Product improvement: Extended Breaking Capacity Rating

SHF 6.3x32 / SHF 6.3x32 Pigtail					0118.2267	
creation date	created by	release date	released by	notification no.	revision	page
2015-01-22	ruettiha	2015-01-28	ruettiha	26945		1 of 2

New Label

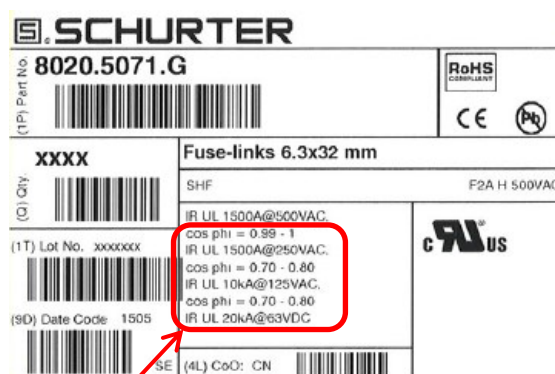
Approval added

Approval added

Interrupting Rating					
AC			DC		
Volts	Amps	Power Factor	Volts	Amps	Time Const.
500 AC	1'500 A	99-100 %	63 DC	20'000 A	<1 ms
250 AC	1'500 A	70-80 %	--	--	--
125 AC	10'000 A	70-80 %	--	--	--
